1 Products affected

2 Type of change

Product Change Notification						PCN - Change of cordset label		
owner	creation date	release date	released by	change order no	rev	page	D40 027 044	
bachmajo	26.06.2019	16.12.2019	limachcl	2017893	Α	1 of 2	D10-037-841

3 Detailed description of change

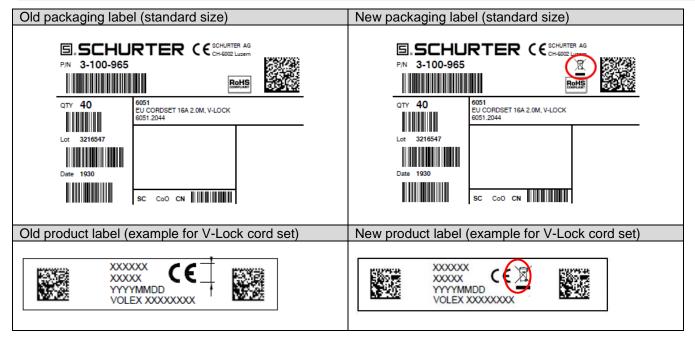
- Modified packaging label
- Modified product label

A new WEEE regulation sets for potential b2c products a new labelling requirement (stroke-through wheeled bin) for the European market.

Label Yes Addition of packaging label and product label.
